# STEREO IMPACT

PROBLEM REPORT

PR-1005

SEP LVPS Top FM1

Figure 1: SEP LVPS Top board Schematic

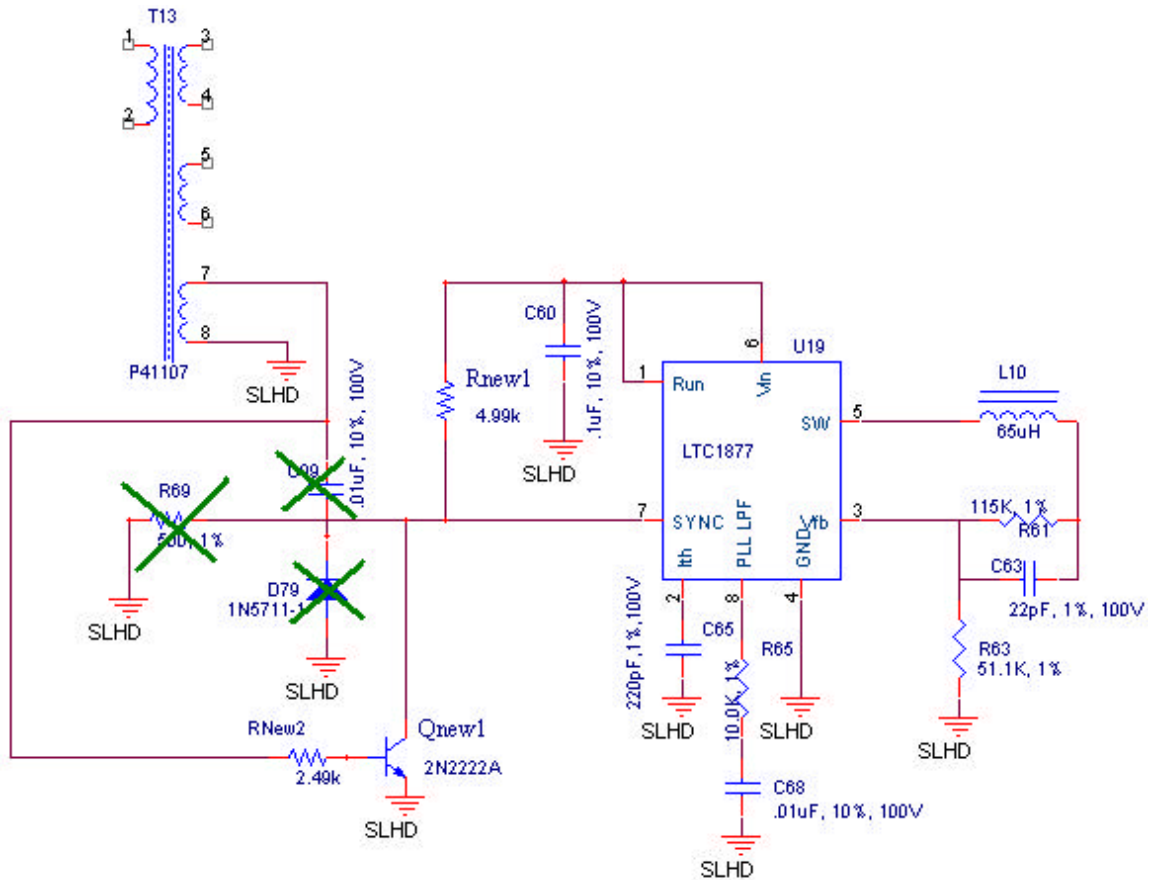
The SYNC signal of LTC1877 should not receive any negative voltages. The Schottky Diode 1N5711-1 does not prevent negative voltages. When the SYNC signal pin goes negative the LTC1877 turns off. This is a design problem, not a layout issue.

1. Remove D79
2. Remove R69
3. Remove C99
4. Install a 2N2222A transistor as shown in Figure 1.
5. Connect the collector (Pin3) of Qnew1 to the cathode pad of D79
6. Connect the emitter (Pin1) of Qnew1 to the anode pad of D79
7. Connect a 2.49K $\Omega$  (Rnew2) resistor to the base of Qnew1 and to C99 (RNC50H2491DS)
8. Connect a 4.99K $\Omega$  (Rnew1) resistor from C91A (5.1V side) to SYNC of U19 (Figure 2 and 3) (RNC50H4991DS)
9. Use shrink tubing where the leads are exposed.
10. During staking process stake, Qnew1, Rnew1, Rnew2 and the Rnew2 feed-through hole.
11. Update the schematics with the changes made to the design.
